DEVIATION REQUEST AND DECISION FORM

Project Name : Estates at Rolling Hills Ranch Filing 1
 Schedule No.(s) : 4200000407 & 4219100002
 Legal Description : See attached

A deviation from the standards of or in Section **2.3.2 Design Standards by Functional Classification, Table 2-6** of the Engineering Criteria Manual (ECM) is requested.

ESTATES AT ROLLING HILLS RANCH
DEVIATION EXHIBIT
LOCATION MAP
PUDSP197
SF191

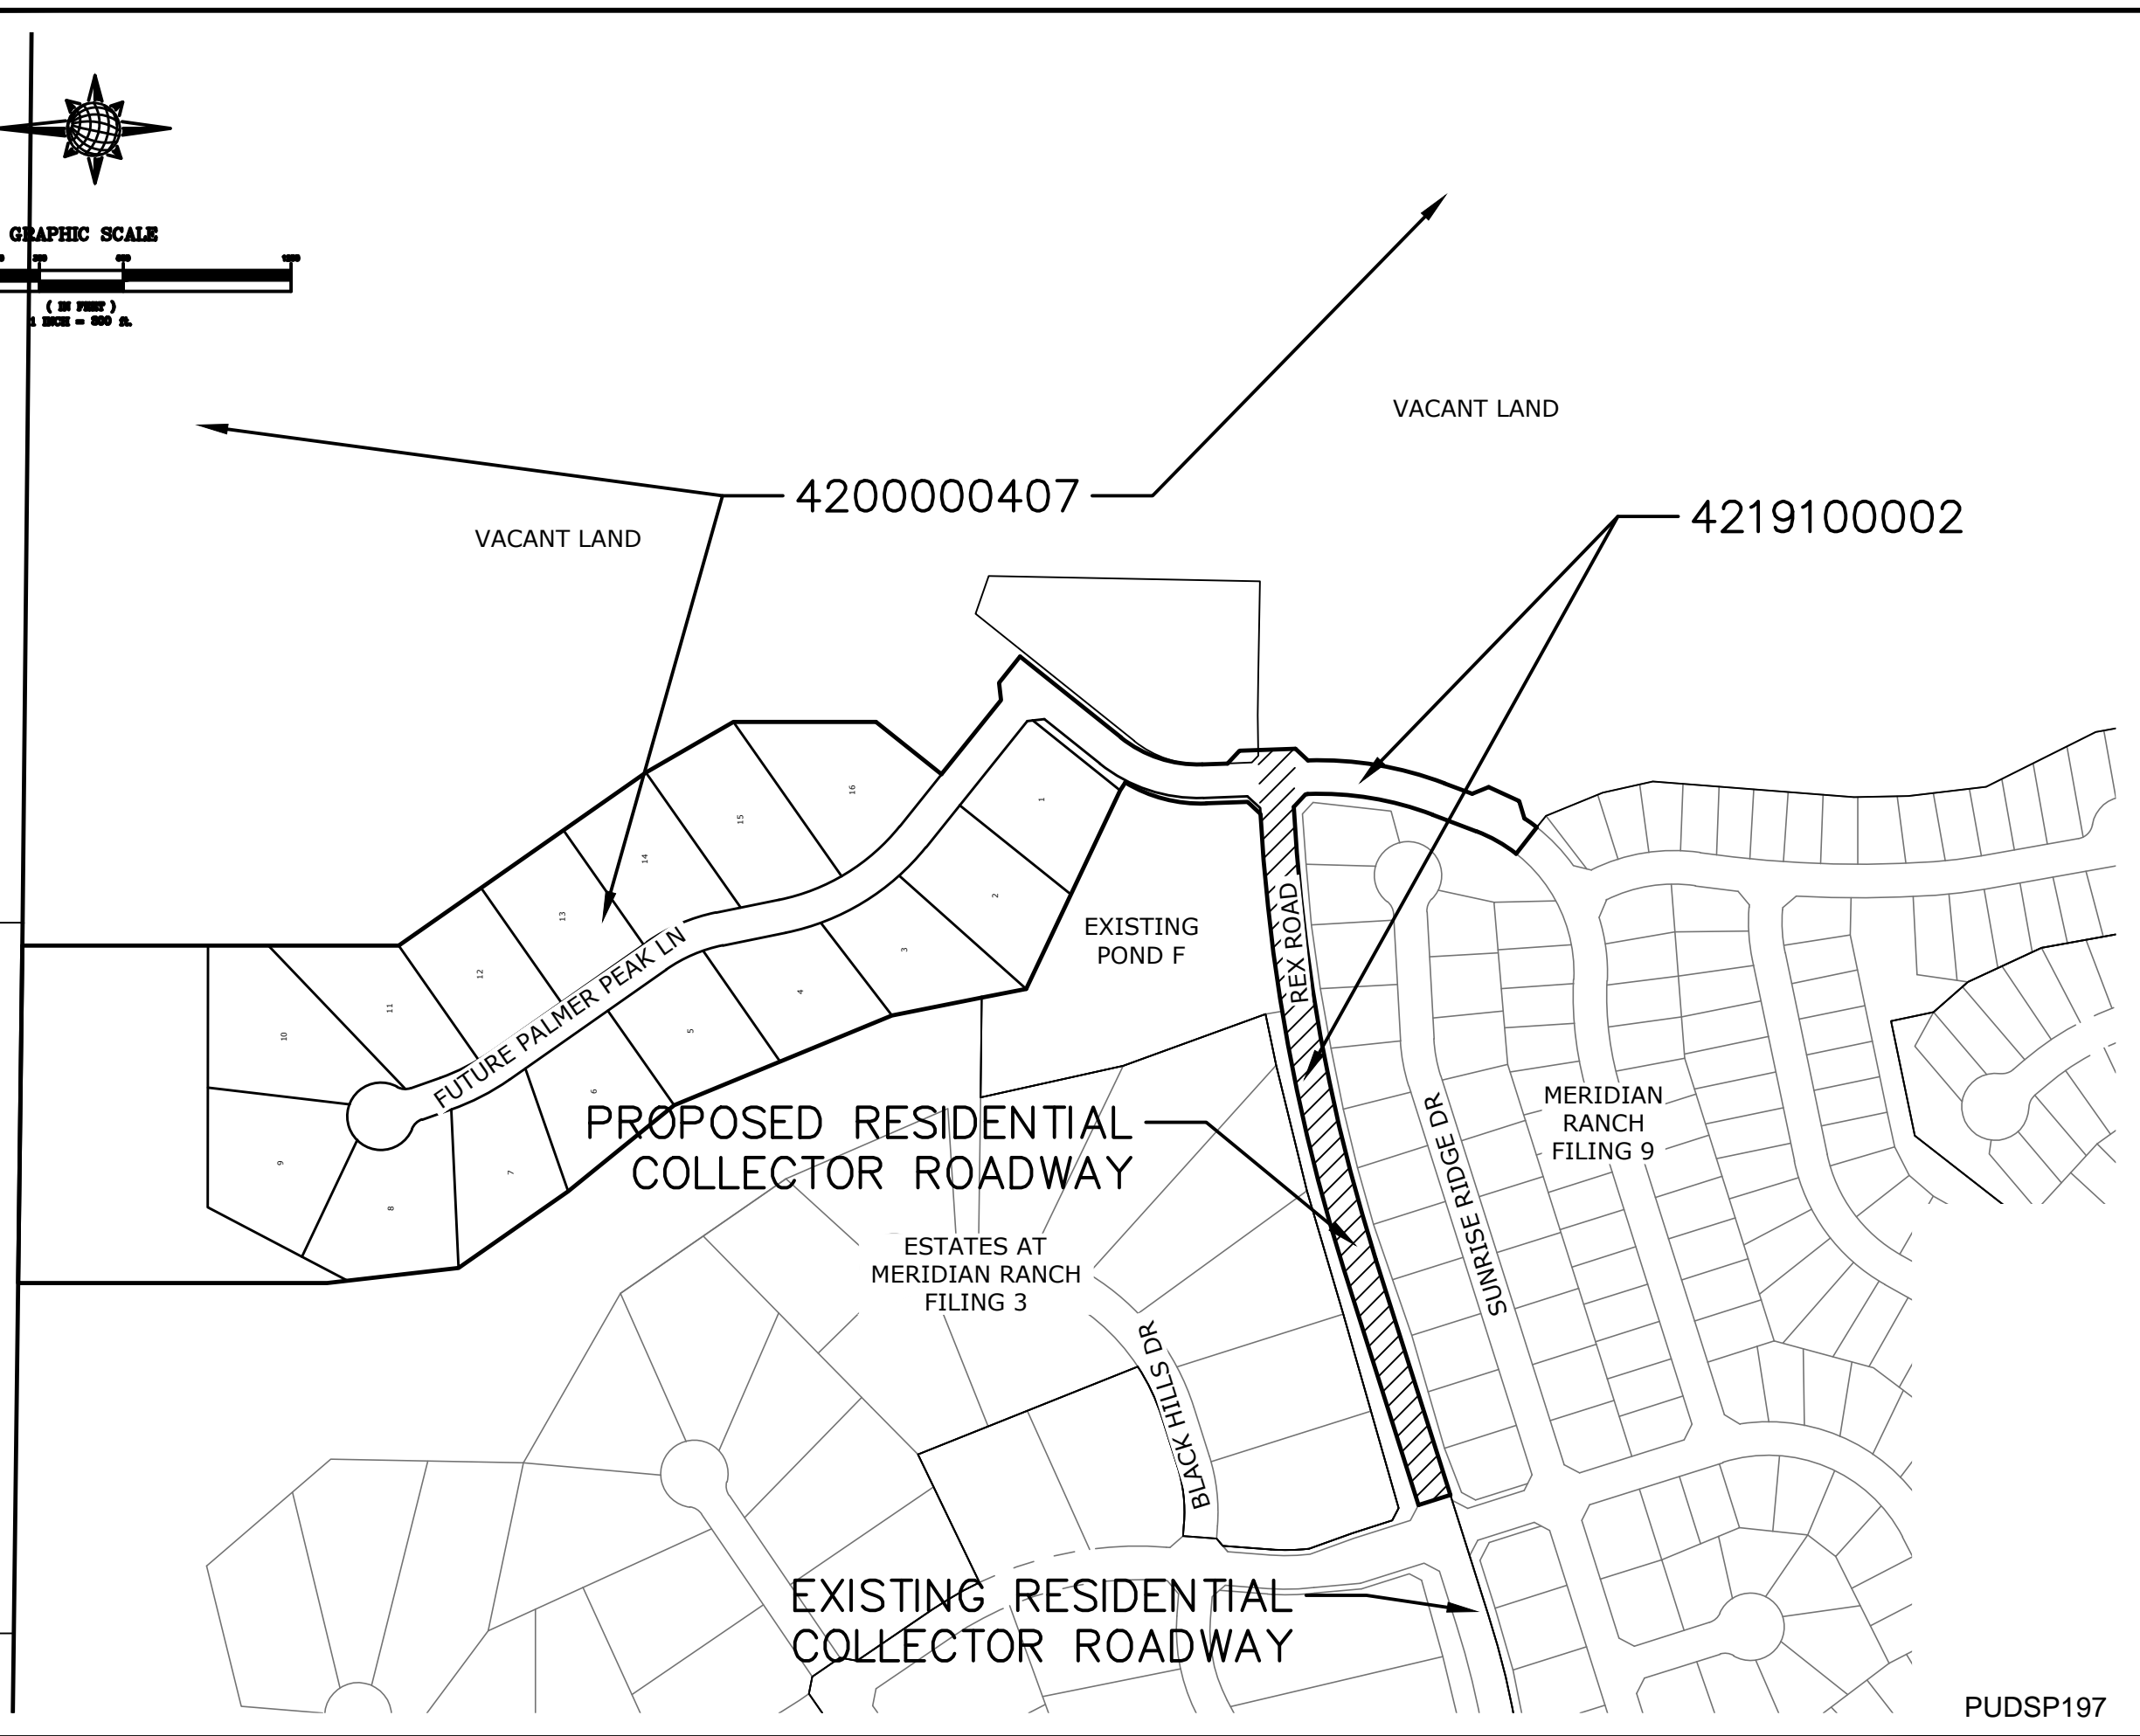
Construct the portion of Rex Road to be located between Pyramid Peak Drive and Sunrise Ridge Drive as a Residential Urban Collector in lieu of the Urban Minor Arterial as identified in the current 2040 Major Transportation Corridor Plan.

The portion of Rex Road between Pyramid Peak Drive and Sunrise Ridge Drive is flanked by two final plat anticipating a 60 foot right of way equal to that already platted west of Pyramid Peak Drive with Estates at Meridian Ranch Filing 2.

The roadway section west of Pyramid Peak Drive was constructed as a Residential Collector.

The proposed alternative matches the existing Rex Road roadway section west of Pyramid Peak Drive that is being extended with this project.

The proposed roadway section is an El Paso County standard section for Residential Collector roads.

The daily traffic volume per the Estates at Rolling Hills Ranch Filing 1 Traffic Impact Analysis prepared by LSC Traffic Consultants, LLC dated September 25, 2019 is estimated to be 7,470 which is below the threshold of 10,000 for Residential Collectors.

The previously recorded final plats for Estates at Meridian Ranch Filing 2 and Meridian Ranch Filing 9 create a corridor of only 60' wide. This provides sufficient room for the Residential Collector. Any other alternative would require the acquisition of property for public and private entities in order to secure sufficient land to construct the Urban Minor Arterial.

The above mentioned Traffic Impact Analysis prepared by LSC Traffic Consultants indicates the long term traffic volume is estimated to be 7,470 vehicles per day well below the threshold for the roadway to be classified as a Residential Collector.

This request has been determined to have met the criteria for approval. A deviation from Section 2.3.2 of the ECM is hereby granted based on the justification provided:
